This gallery shows some pictures of bad solderings - they should prevent you from making the same errors (feel free to add even more pictures here!)

From:  
<http://wiki.midibox.org/> - **MIDIbox**

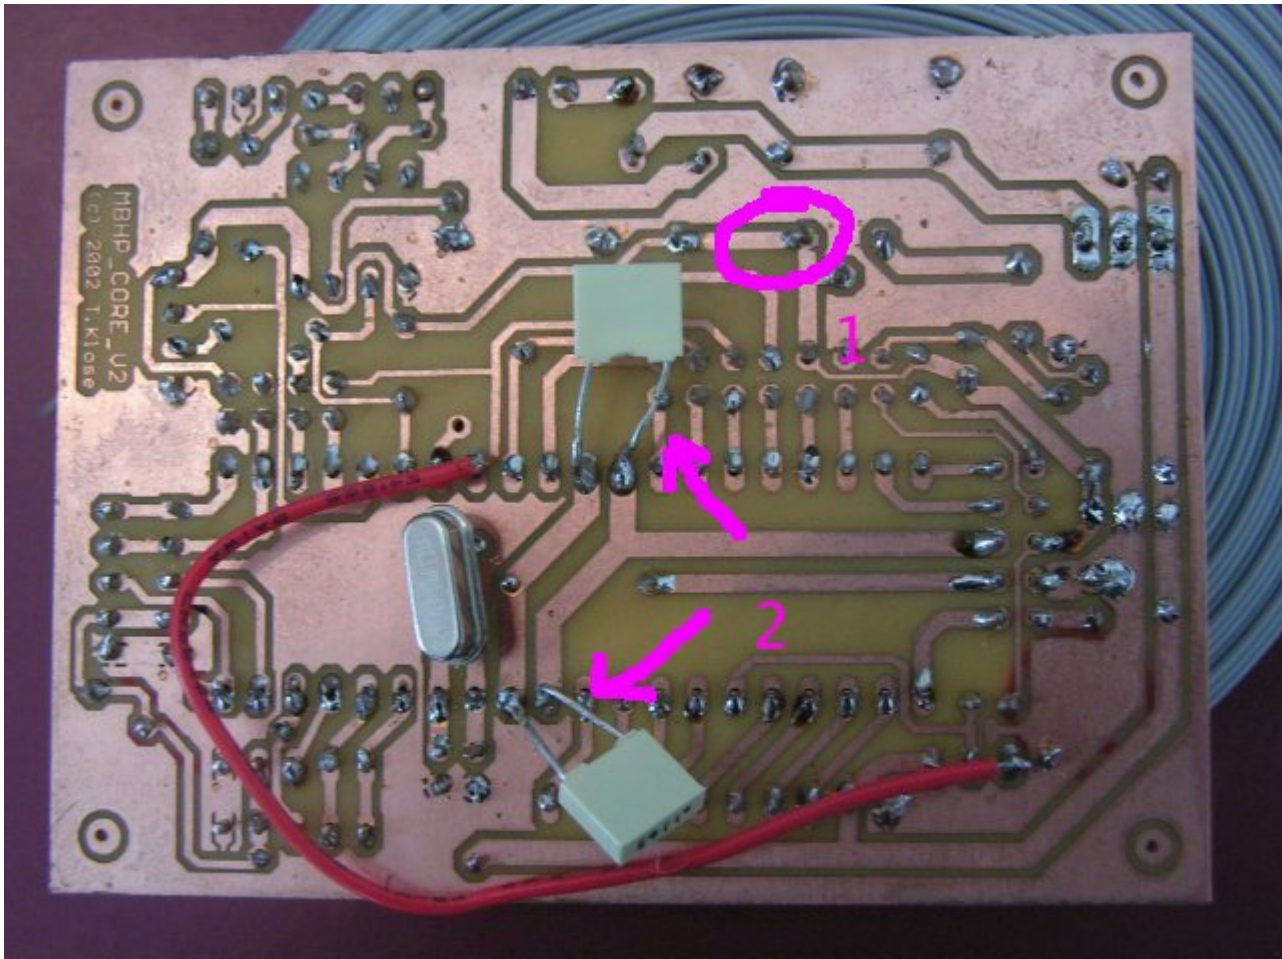
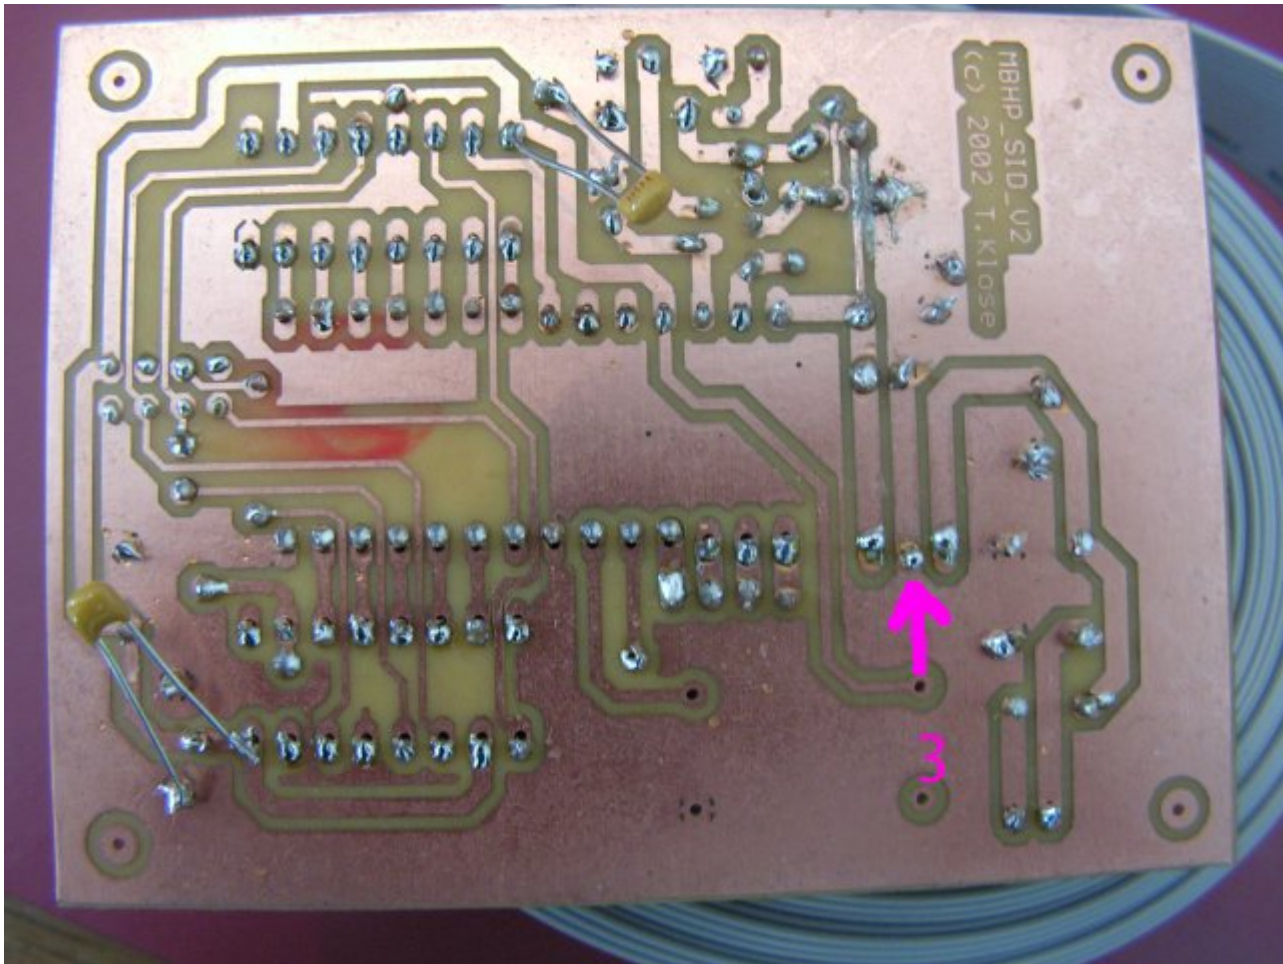
1: the core module has some bad solderings (loose connections), which could lead to failures. There are also missing solderings (e.g. 33pF cap below crystal). It makes sense to solder each pad again, the [Soldering](#) guide in the Wiki gives some useful tips

2: the legs of the caps should be cutted, otherwise they can cause a short circuit which can damage the PIC!

3: this seems to be a bad ground connection directly at the 78xx - it can lead to the wrong voltage. Here the same: just solder the pads again, it will help

And same like above: the long cap legs need to be cutted, the danger for shorts is too high!
